Meeting Date: June 7, 2015

Hearing Body: Planning and Zoning Commission

Location: 60 Sinagua Drive

Project Summary: New 3,808 square foot Commercial Warehouse

LIGHTING AND SIGNAGE PLAN
 SCALE: 1/8" = 1'-0"

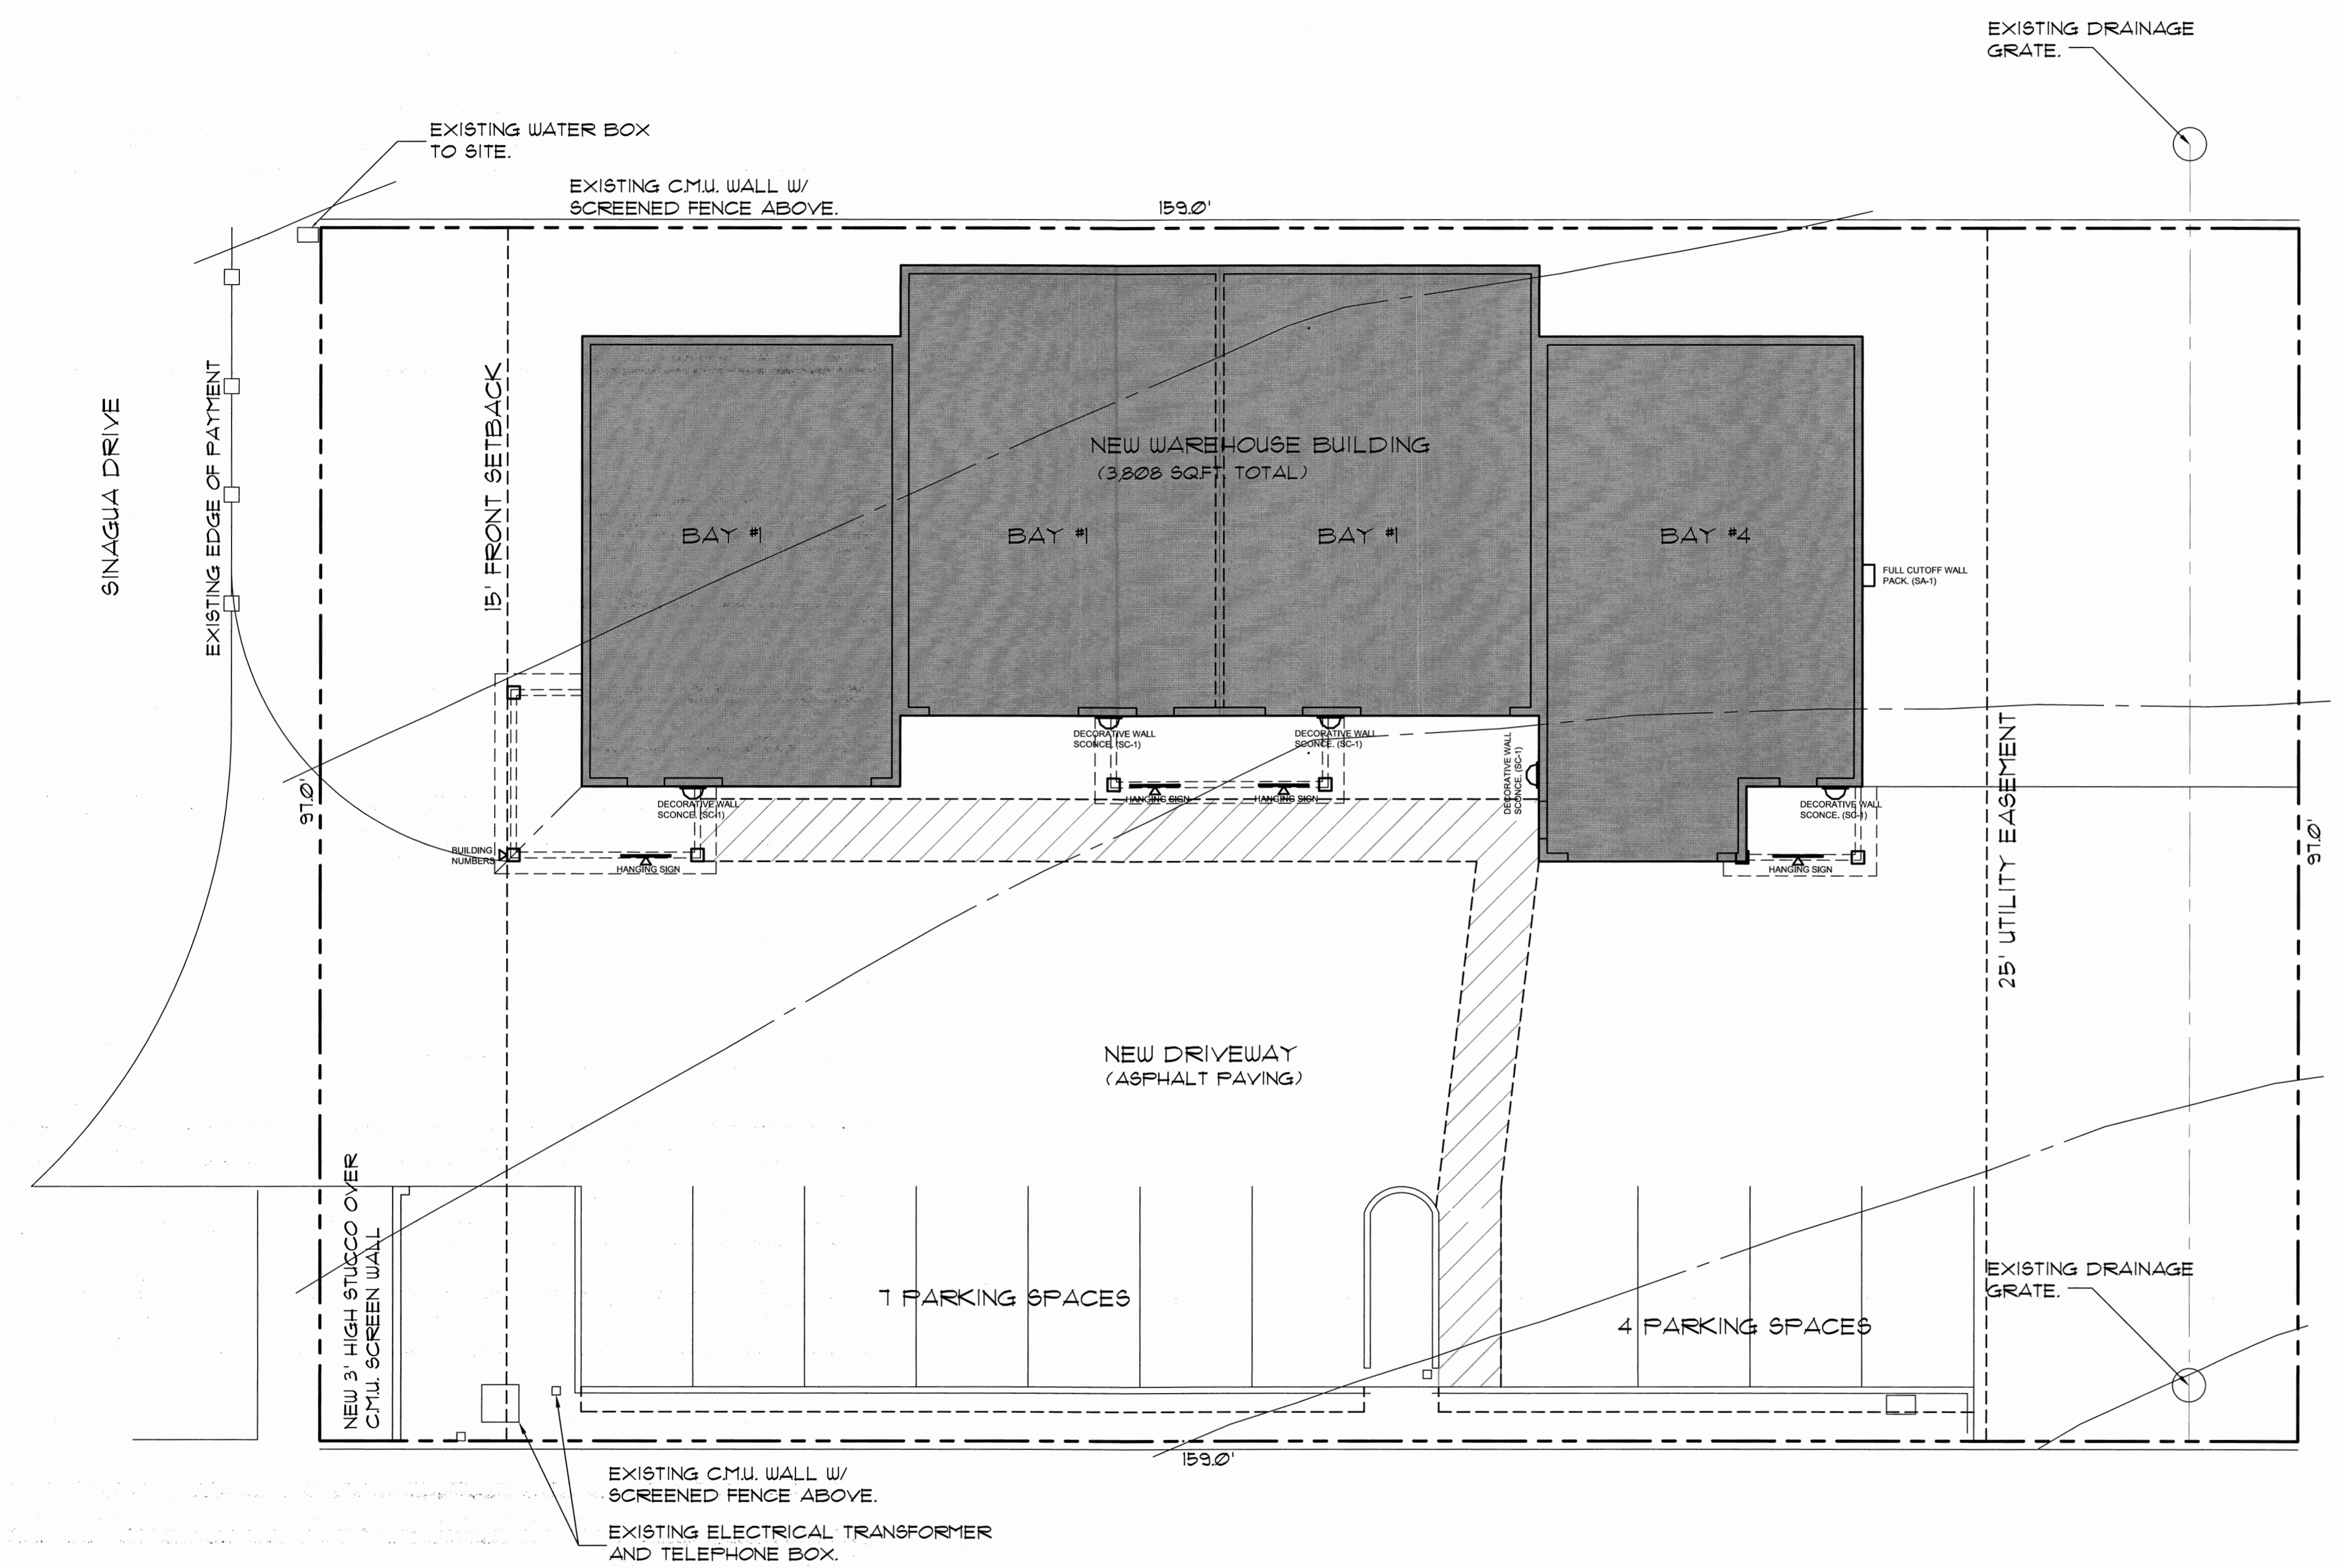
911.05 Outdoor Lighting Standards
	<i>Evaluation:</i> All lighting proposed is Dark Sky Compliant. The survey provided shows the property as approximately 0.354 acres. Based on this acreage, a maximum of 35,400 lumens would be allowed. The lighting plan submitted by the applicant proposes 8,350 lumens.
	<i>Compliance:</i> <input checked="" type="checkbox"/> Yes <input type="checkbox"/> Partial <input type="checkbox"/> No <input type="checkbox"/> Not Applicable
912 Off-Street Parking and Loading Requirements and Standards
